Subject:	Heat Lamp Upgrade
Release Date:	October 25, 2017
Systems Affected:	DSS-200 Series 2 CE, DSS-200 Synergy and Synergy Integra
Reference Components:	12-8882-092 ASSY, HEAT LAMP 12-8882-117 ASSY, PKG, BULB, HEAT LAMP 73-0001-001 QUARTZ LAMP 1000W. 120V 73-0001-010 LAMP, HALOGEN, 120V, 1000W
Summary:	Upgrade kit to the original stage light style heat lamp to provide a longer lifetime bulb and higher efficiency lamp solution.

Retrofit Kit PN 26-8882-906 HEAT LAMP UPGRADE KIT

Technical Memo #018.1

Trans axial bulb, cut out in reflector, and dull uneven surface caused slow center drying

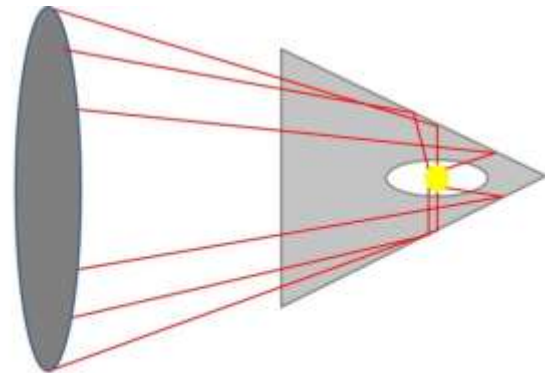
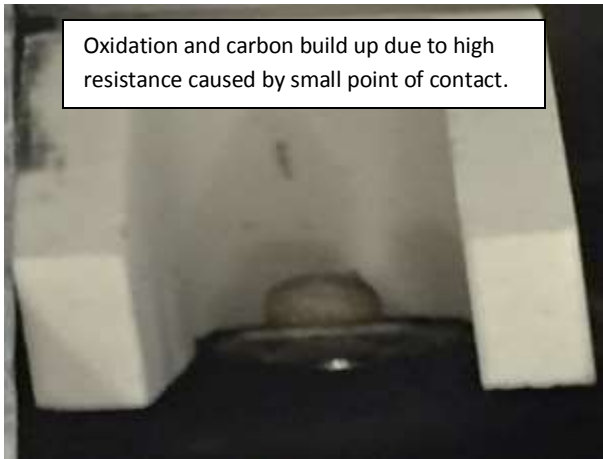
The original stage lamp used a trans axial bulb and an aluminum reflector, with slots cut out of the sides, and a spring load contact. The effect of this configuration was a lack of center focus on the target wafer, loss of efficiency (dead bands), heat transfer to the back of the reflector due to the cutouts, and a high resistance in the small surface of the spring loaded contacts.

Axial bulb, full radius reflector, and high polished surface allows for center focused, high energy transfer

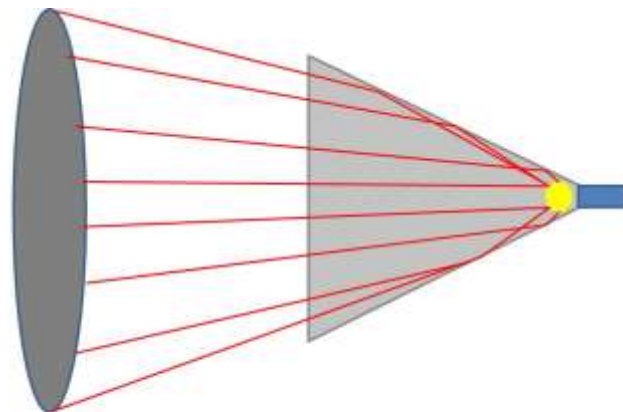
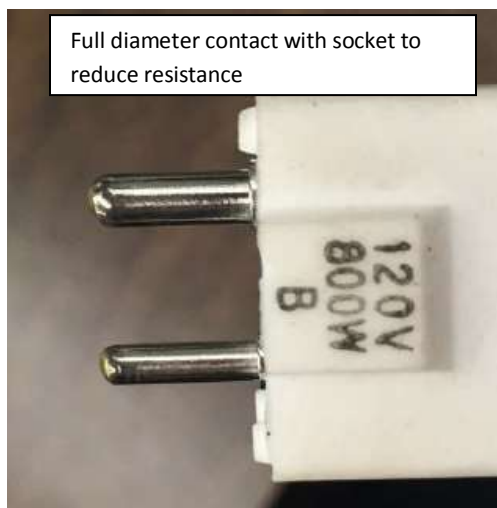
The Entrepix solution was to provide a center focus axial bulb, electropolished full radius reflector, and a large contact area for the lamp terminals with a positive locking mechanism. The results are a lower wattage bulb with increased thermal output and a 10x lifetime.

Assembly installed in Spin Cover

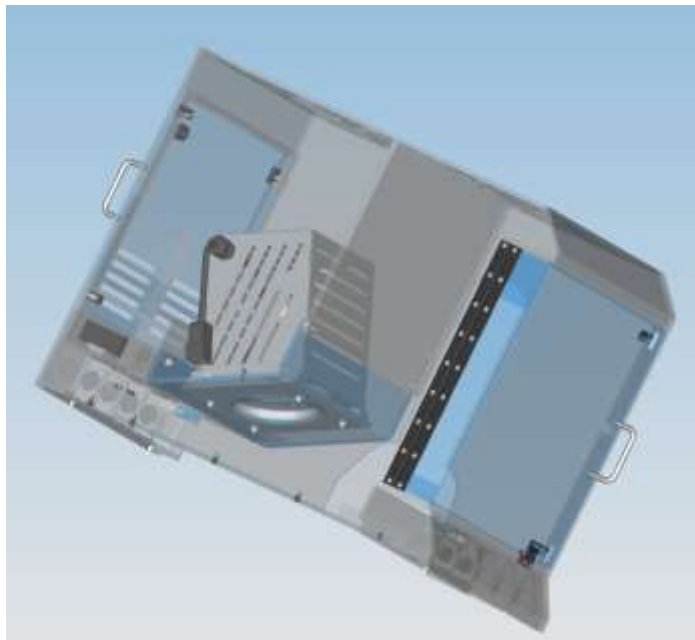
A retrofit kit is required to replace the original stage lamp design. The retrofit fits into the existing Spin Cover and includes a new slotted heat shield to allow for laminar airflow to cool the bulb and reflector while protecting against inadvertent contact. In addition to the shield, lamp, and reflector the kit consists of mounting hardware and a thermal gasket to add protection for the acrylic Spin Cover.
